**Graphite Core Safety Case NP/SC 7766 Stage Submission 1:
An Operational Safety Case for Hunterston B R3 to a Core Burn-Up of
16.425TWd following the 2018 Graphite Core Inspection Outage
Civil Engineering Assessment**

Assessment Report ONR-OFD-AR-20-002
Revision 0
May 2020

Figure 1 – Secondary response spectra comparison at core boundary for PML synthetic input motion for legacy and final PCPV models (After Ref. 11, Figure 54)

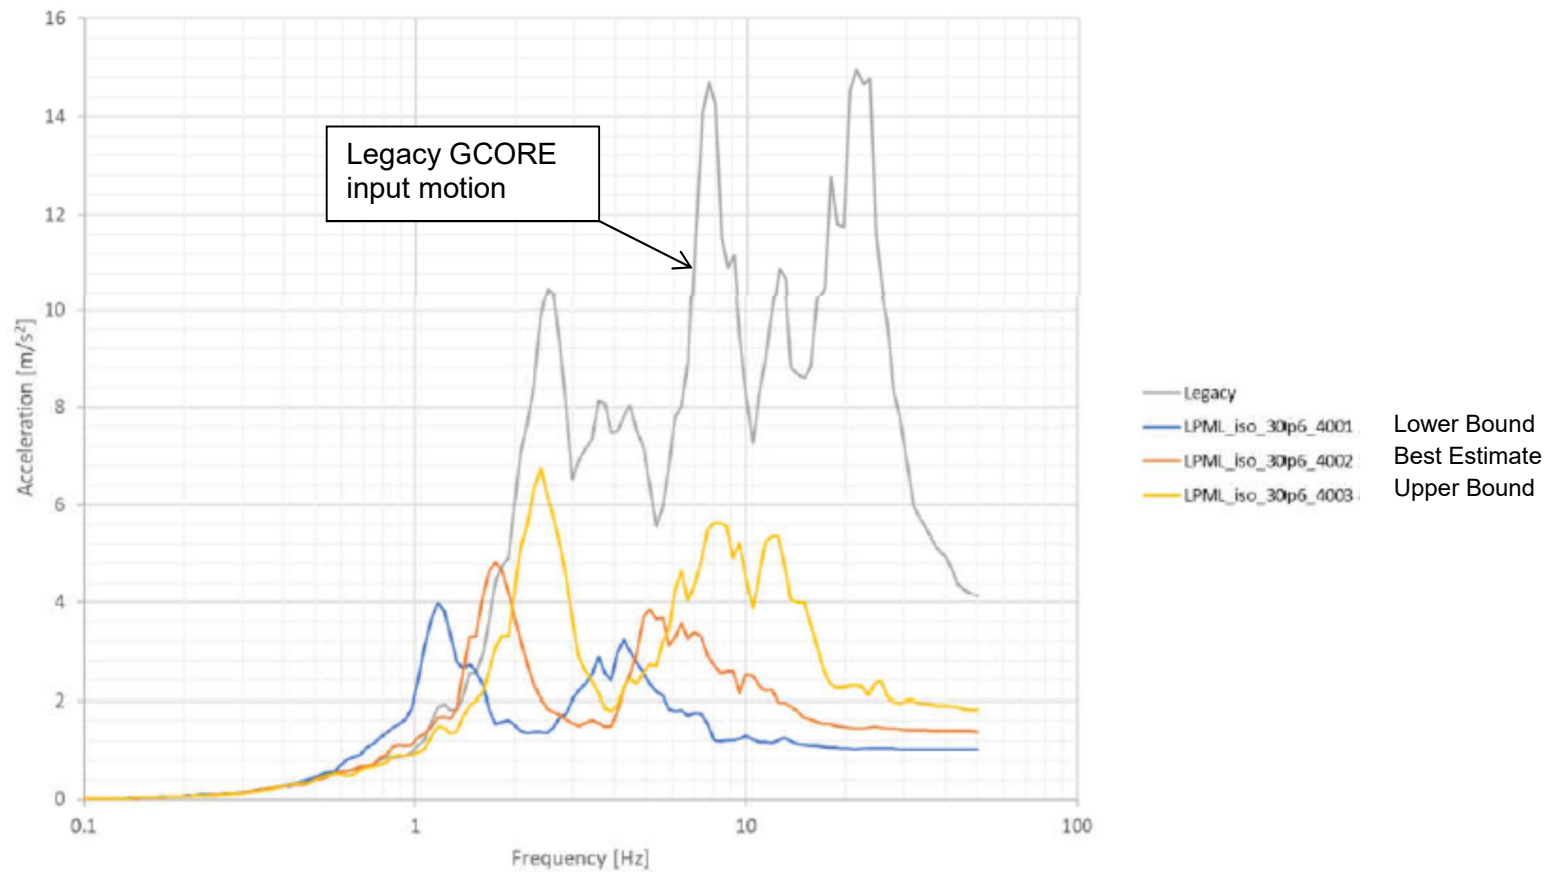
84. Based on the evidence presented in Figure 1, I agree with the argument that the core boundary seismic motion derived from the upper bound PCPV model, at frequencies corresponding to the peak core response (around 2.4 Hz) is less than that produced by the legacy analysis on which the previous safety case NP/SC 7716 (Ref. 15) was based. A margin therefore exists between the current seismic input motion and that used in previous safety cases.

102. For a beyond design basis assessment, best estimate properties can be considered (SAP FA.15). The safety case has shown (see Figure 1), that there is a significant margin in terms of seismic input to the core between using BE and UB properties for the PCPV modelling, which provides a measure of confidence that the core will be resilient to greater levels of earthquake than the design basis earthquake.

Figure 2 – HPB 84th percentile target response spectra – North-South core boundary secondary response spectra for the LB, BE and UB Final model (After Ref. 11, Figure 44)

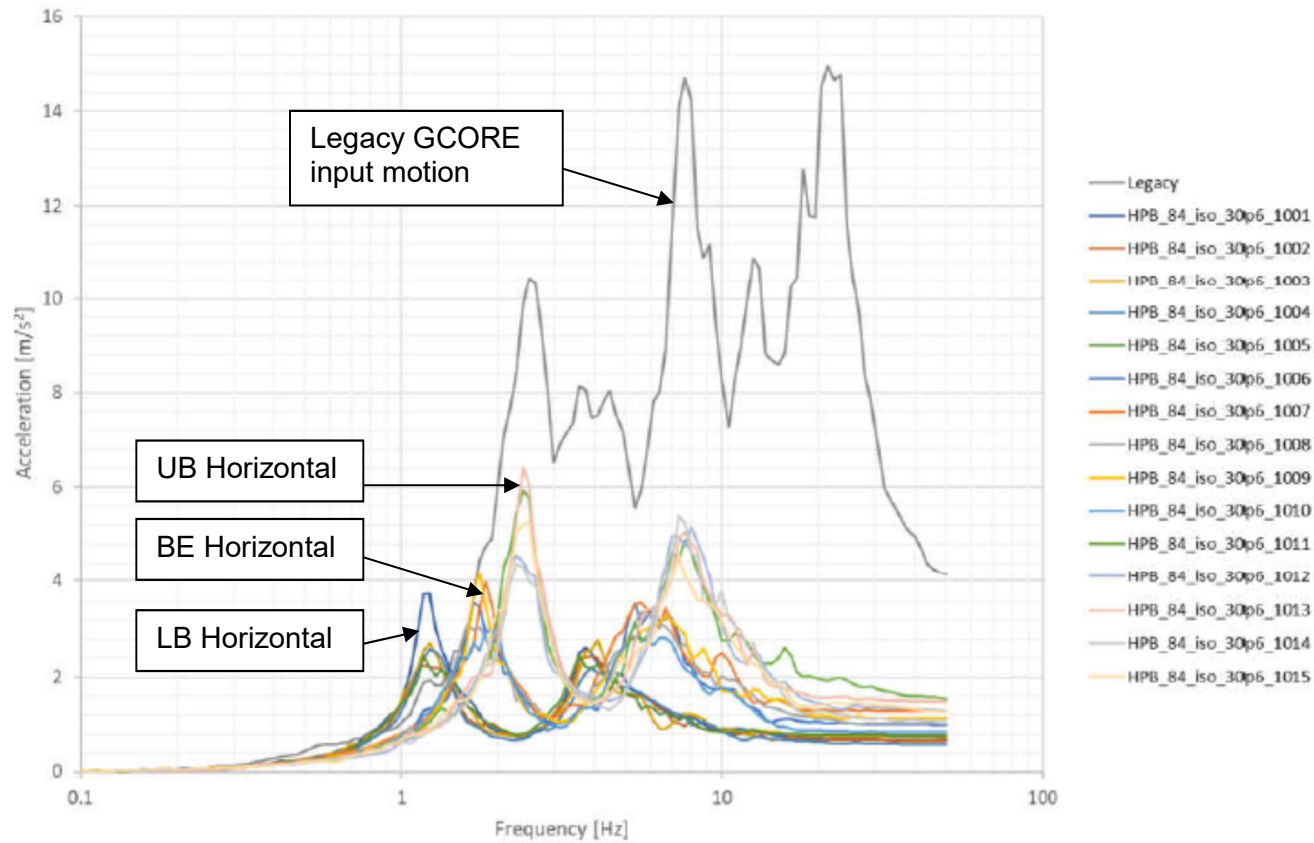
89. Comparison of Figure 1 (core boundary secondary response spectra obtained using the PML synthetic ground motion) and Figure 2 (core boundary secondary response spectra obtained using the 84% confidence level HPB target response spectrum), indicate a similar response for the critical UB case at the frequency for maximum core response (around 2.4 Hz). For Figure 1, the peak spectral acceleration is 6.8 m/s^2 compared with 6.4 m/s^2 for the most onerous set of modified real records in Figure 2. I agree that the synthetic PML ground motion gives core boundary responses that are consistent with those derived based on modified real recorded motions and is adequate for use in the essentially linear analysis of the PCPV model in the frequency range of interest to core response and hence is fit for purpose. The GCORE modelling, which uses seismic input from the PCPV model, is non-linear and for this work, the synthetic PML ground motions are inconsistent with the requirements of RGP. I therefore agree with the Licensee that there are weaknesses in this leg of the evidence (called Criterion 2 in the safety case, see Section 3.3.3).

Figure 3 - Core distortion as measured by cumulative interstitial channel score 3BL – CEDTL core - PML synthetic input motion - Comparison of four different PCPV property sets (after Ref. 26, Figure 8-3 and based on HPB)

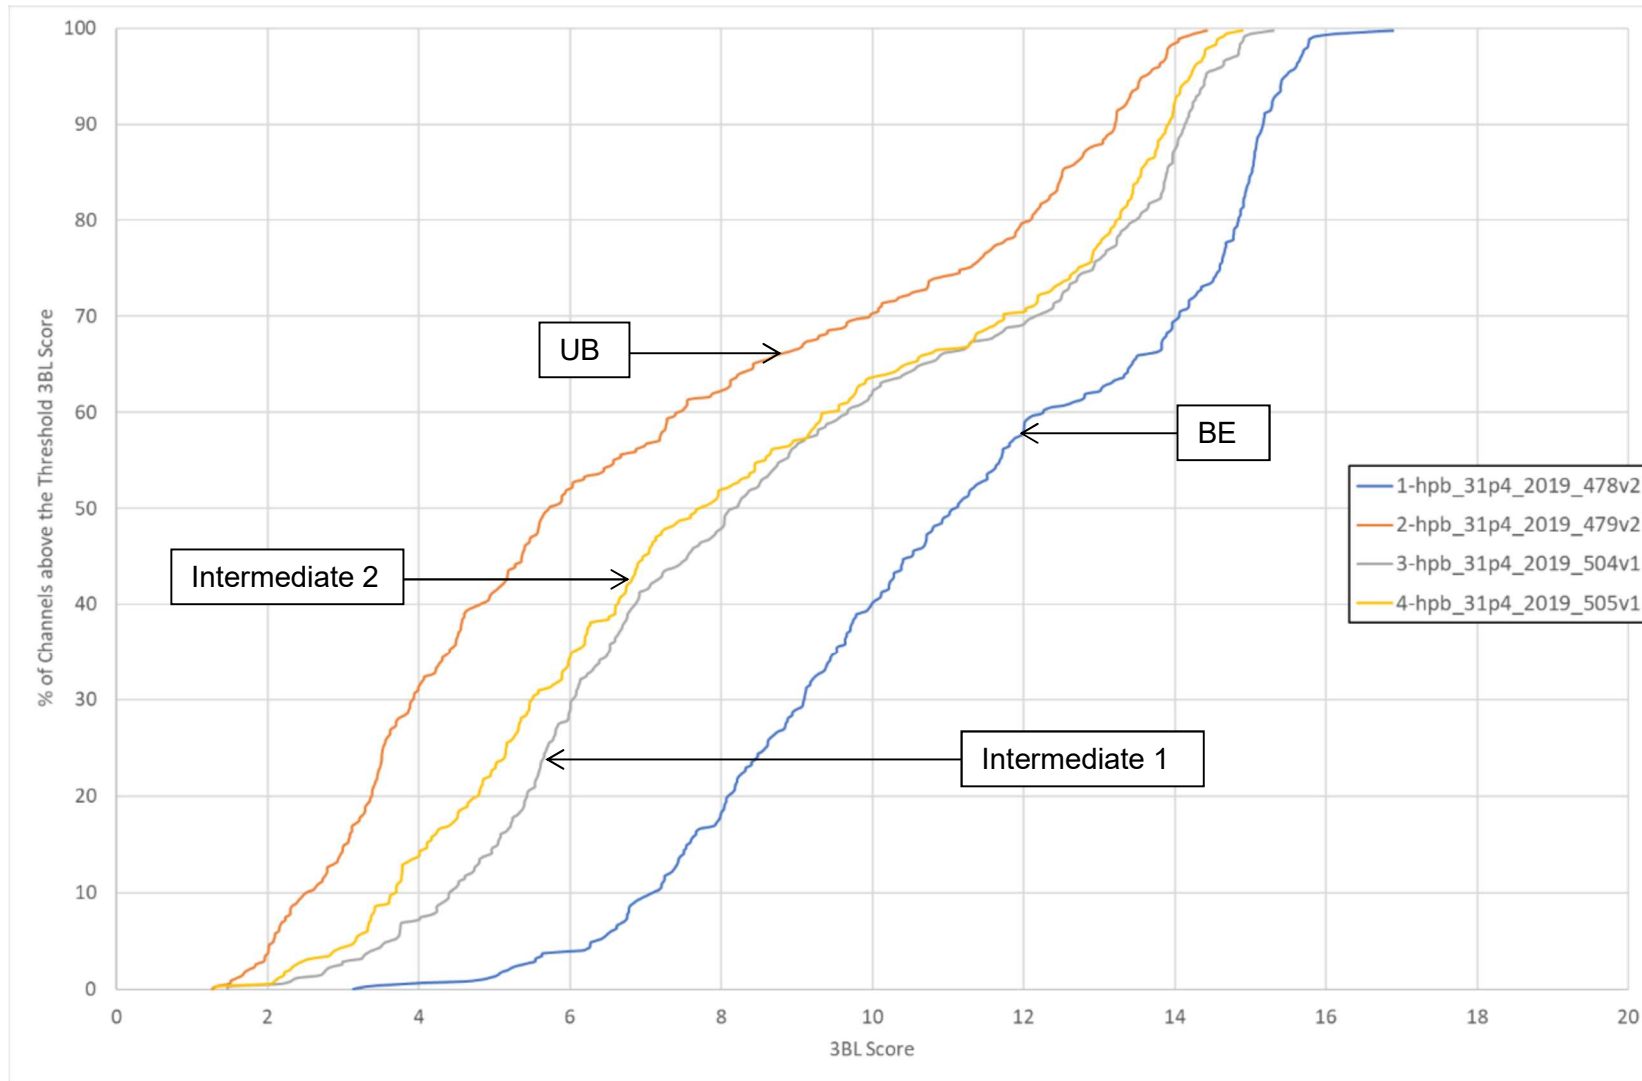
77. The results of the HPB cumulative core distortion scores are shown in Figures 3 and 4 and show that the UB property set leads to the maximum core distortion, thus confirming previous data for the HNB R4 core (Ref. 11) that the UB property set is the most onerous for the core condition represented by the CEDTL. This meets the expectations of SAP ECE.13 that the data used should be demonstrably conservative, as the probability that the SSI, backfill and bearing properties all assume their UB values simultaneously is low.
